PLANNING DIRECTOR'S VARIANCE
1231 "I" STREET, SUITE 200, SACRAMENTO, CA 95814

- APPLICATION:**
- A. Negative Declaration
 - B. Mitigation Monitoring Plan
 - C. Planning Director's Variance Time Extension to reduce the required side yard setback from five feet to three feet on 0.11 ± vacant acres in the Standard Single Family (R-1) zone.

LOCATION: 1832 51st Street

APPLC. NO. P92-126

NORTH ELEVATION
SCALE: 1/4" = 1'-0"

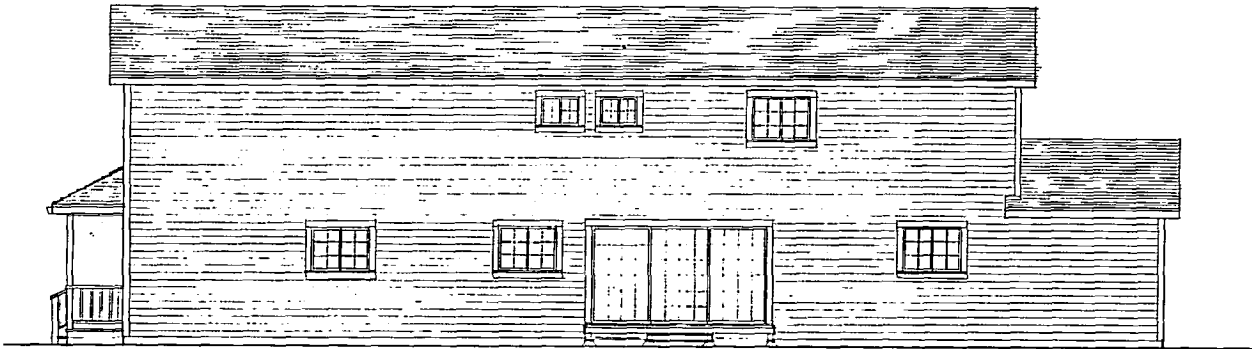
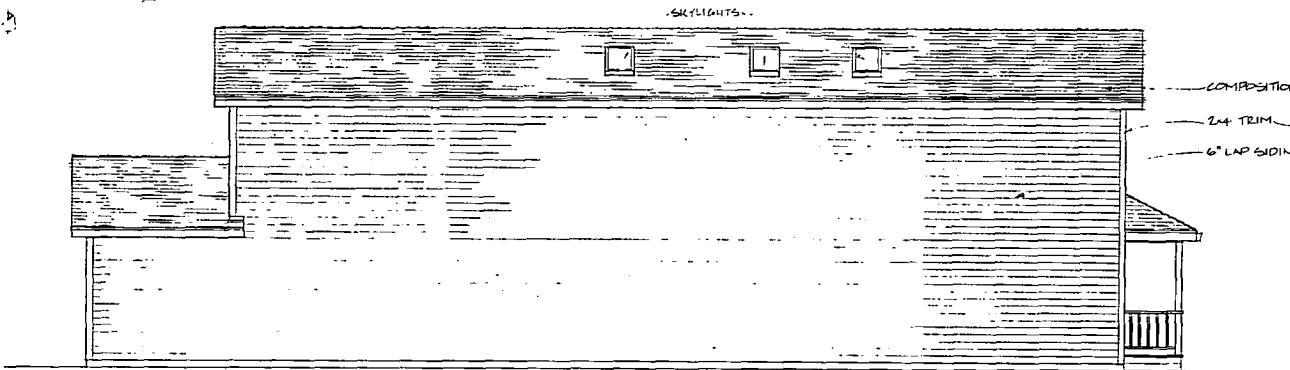
The proposed elevations show horizontal lap siding with a composition shingle roof. Staff recommends a 2x12 wood band painted in the trim color be added to the north and south elevation to align with the first story roof. Staff also recommends the roof be constructed with 25 year laminated dimensional composition shingles and the garage door be a metal sectional door.

- 1. The applicant shall add a 2x12 wood band painted in the trim color to the north and south elevation to align with the first story roof. The roof shall be constructed with 25 year laminated dimensional composition shingles and the garage door shall be a metal sectional door. The elevations shall be revised and submitted to Planning Staff for review and approval prior to the issuance of building permits.
